IRON GATES RESIDENTIAL DEVELOPMENT

Revised Engineering Services and Civil Infrastructure Report

Report No F0002-AA007094-AAR

This Report was revised on 23rd July 2019 in order to Consolidate the Engineering Services Report and to include all amendments to the Report and include the additional details outlined in the response to RVC's recent Information Request dated 2nd February 2019. Below is a list of amendments and additions made to this report and the general engineering documents.

Figure 2- Typical Infiltration Strategy

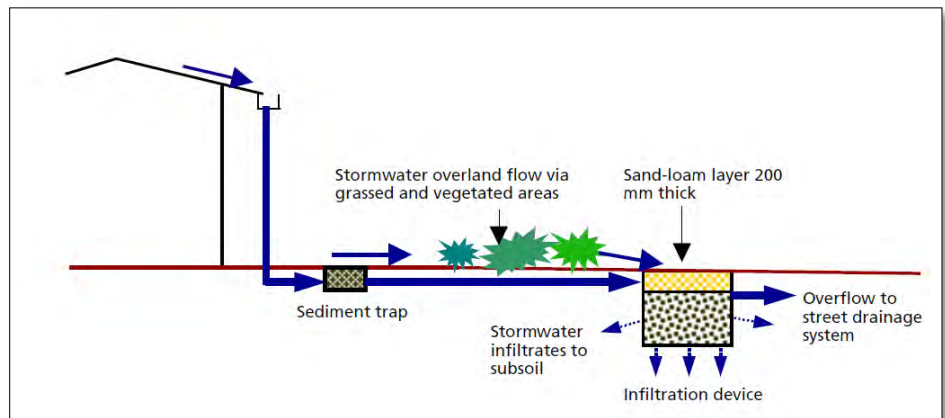
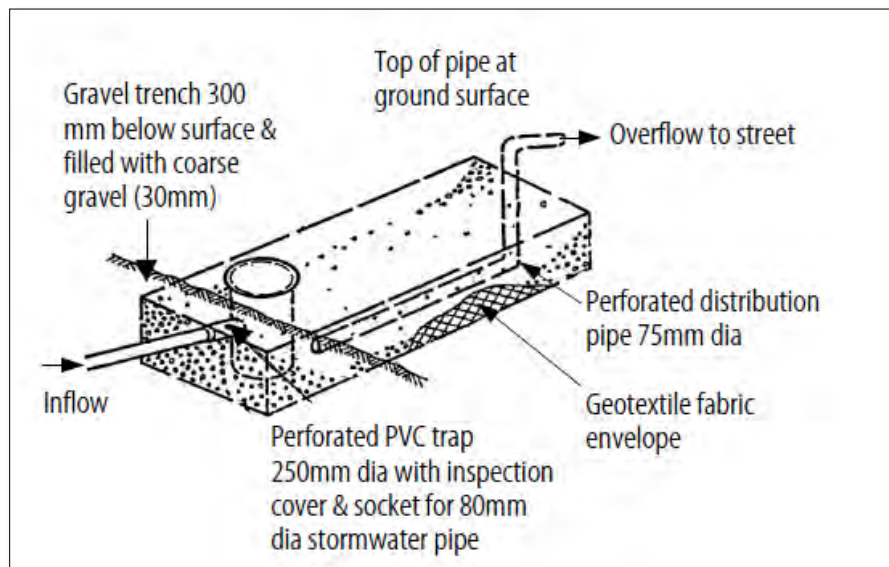
- How are the pits be protected from future owners constructing over the pits or reducing the effectiveness of the pit. An easement on title may be an appropriate method to protect this infrastructure.
